VIRGINIA ELECTRIC AND POWER COMPANY
SURRY POWER STATION UNITS 1 AND 2
PROPOSED TECHNICAL SPECIFICATIONS CHANGE
BURIED FUEL OIL STORAGE TANK INSPECTION AND RELATED REPAIR
REQUEST FOR ADDITIONAL INFORMATION

Response to NRC Request for Additional Information -
Proposed Technical Specifications Change Request
Buried Fuel Oil Storage Tank Inspection/Repair

Surry Power Station Units 1 and 2
Virginia Electric and Power Company
(Dominion)

FIGURE 1 – TIME LINE

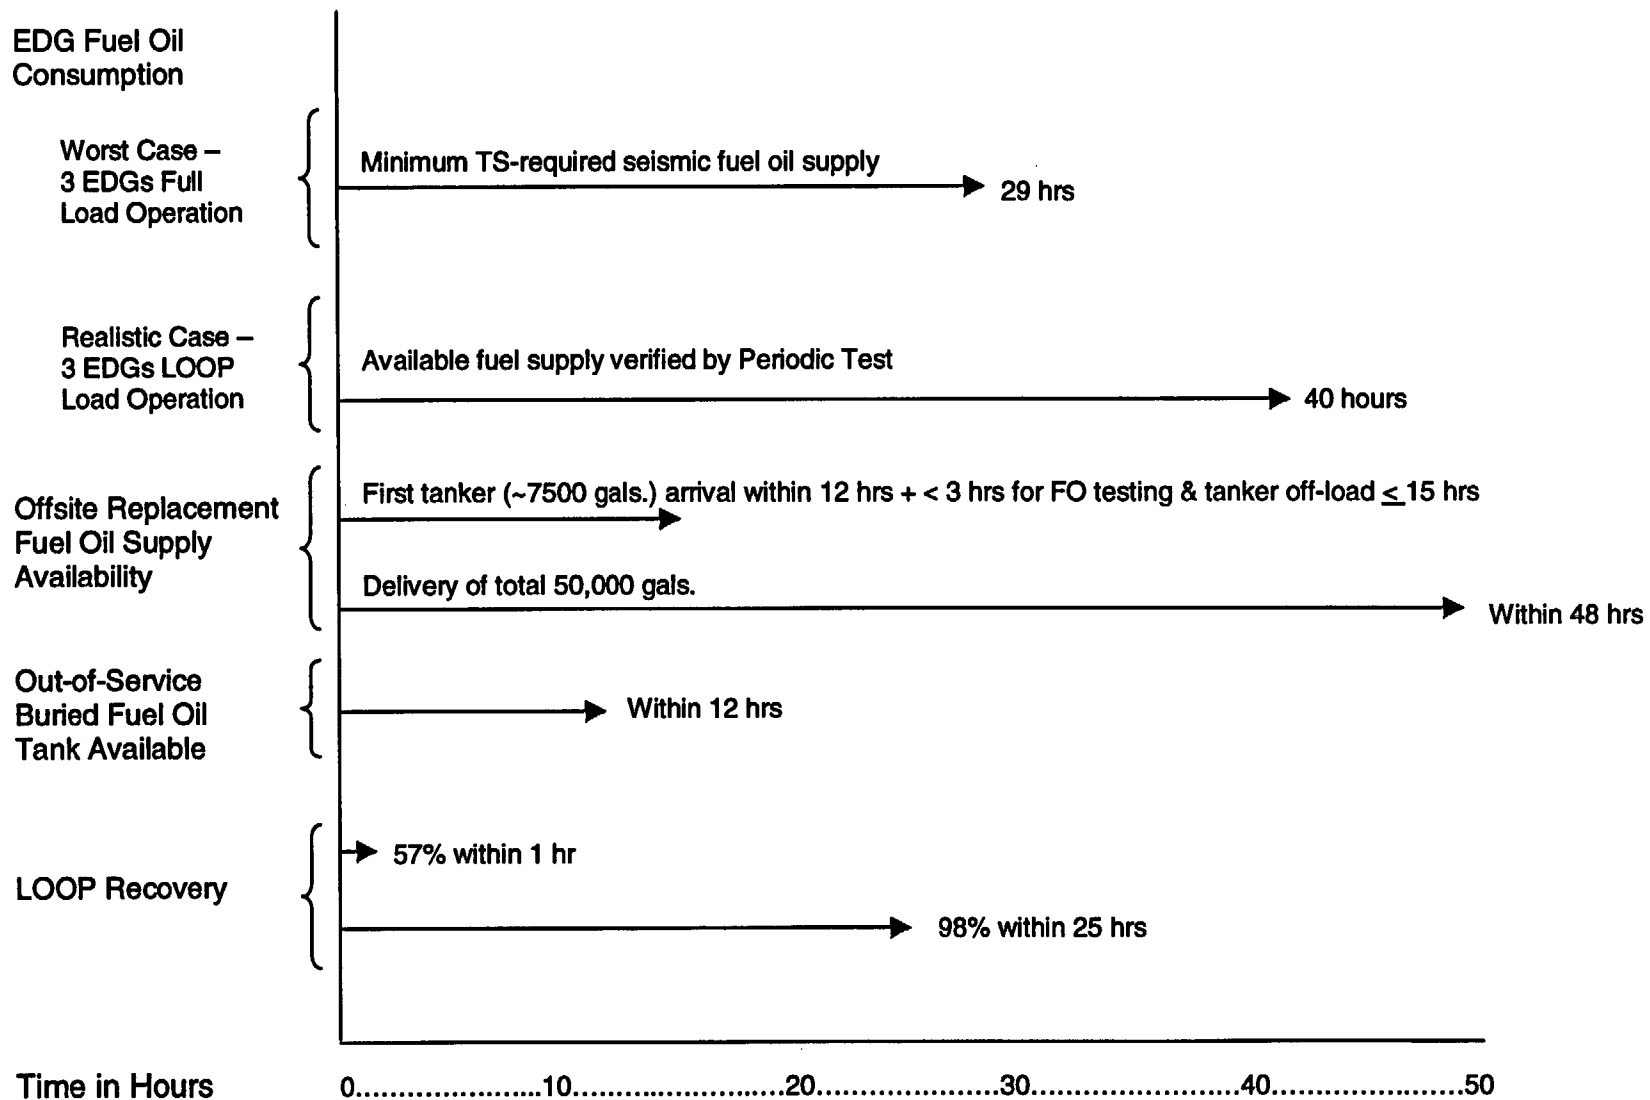
- 1. The information that was requested in Q3 is critical in determining how much time is available for the licensee to obtain off-site fuel oil and refill the only remaining safety-related, seismic, Category 1 storage tank before the 17,500 gallons is depleted. Therefore a more complete response to the specific question that was asked is required in order to judge whether or not a 48 hour delivery contingency is appropriate for their specific situation. I only consider 17,500 gallons of fuel oil to be available because it is the only seismic, Category 1, safety-related source of fuel oil. The other sources that are discussed are good to know about, but they cannot be relied upon for the worst case scenarios that must be considered. The licensee needs to determine how much time they have available for getting more fuel oil to the site (including how much time is needed to begin filling the tank), and this is the time that should be proposed in the submittal (48 hours may not be appropriate).*

The following discussion demonstrates that the proposed TS change, along with clarifying committed actions contained in this letter, ensures the availability of sufficient fuel oil to support EDG operation. Figure 1 presents the key elements of the time line, which are discussed in the following paragraphs.

With one buried fuel oil tank taken out of service for inspection, the following TS-required seismic fuel oil sources will be available. The proposed TS 3.16.B.4.b requires $\geq 17,500$ gallons in the in-service buried fuel oil tank. In addition, the existing TS 3.16.A.1 requires at least 290 gallons of fuel in each EDG's day tank. In the event that emergency power is required, the three EDGs will auto-start and run. For the purposes of addressing the worst case event, full load operation and the associated fuel consumption for the three EDGs is assumed. The minimum TS-required seismic fuel oil volumes will support approximately 29 hours of three EDG full load operation.

In addition to this worst case event, a more realistic event can be defined as one in which the available fuel oil in the seismic tanks is considered, along with estimated EDG loss of offsite power (LOOP) loads and associated fuel consumption for the three EDGs. In this case, the periodic test conducted once a shift verifies a buried fuel oil tank level of 18,000 gallons and a day tank level of 750 gallons for each of the EDGs. This available fuel oil supply will support approximately 40 hours of three EDG LOOP load operation.

Prior to removing a buried fuel oil tank from service for inspection, the proposed TS 3.16.B.4.a requires verification of availability of 50,000 gallons of replacement fuel oil offsite and transportation to deliver that volume of fuel oil within 48 hours. This verification is accomplished by contact from the station with Dominion's Oil Operations and Supply group located at Dominion's Innsbrook Technical Center. If needed, this fuel oil would be delivered by seven tanker trucks each carrying approximately 7,500 gallons from a terminal in Richmond, VA. The fuel oil carried by each tanker truck will support approximately 12 hours of three EDG full load operation (or 15 hours of three EDG LOOP load operation). Upon identification of the need for the offsite replacement fuel oil, the Oil Operations

and Supply group would be contacted a second time to initiate the delivery. Arrival of the first tanker truck onsite will be within 12 hours following notification of need. This delivery time commitment will be specified in the implementing procedure(s) for the buried fuel oil tank inspection activities. Upon arrival of a tanker truck onsite, necessary fuel oil testing for immediate acceptance criteria and tanker off-load could be completed within 3 hours (i.e., completion of testing within 2 hours and gravity feed to the buried fuel oil tank within 1 hour). Thus, the initial delivery of fuel oil would be available for use within 15 hours, and the delivery of the total 50,000 gallons will be complete within 48 hours as required by the proposed TS 3.16.B.4.a.

As noted in our April 16, 2003 letter, it is anticipated that the out-of-service buried fuel oil tank could be refilled and available within 12 hours. This 12-hour time frame assumes up to 8 hours to complete the activities identified in our letter, up to 2 hours to gravity fill the buried fuel oil tank from the above ground fuel oil storage tank, and an additional two hours for conservatism. In the event that the above ground tank is not available, the fuel oil from a tanker truck would be gravity fed to the buried fuel oil tank.

Another key consideration in the worst case event is the time for recovery of a LOOP event. Based on documented historical data through the year 1999, 57% of LOOP events are recovered within 1 hour and 98% are recovered within 25 hours, which is less than the worst case fuel depletion time of approximately 29 hours. This focus on a LOOP event is appropriate since, as indicated in our April 16, 2003 letter, the occurrence of earthquake or LOCA concurrent with a buried FO tank out of service is negligibly small ($6E-8$ /year and $1.8E-8$ /year, respectively), and concern with respect to a severe weather event is essentially eliminated based on either predictability of the occurrence or the ability to return the out-of-service tank to available status.
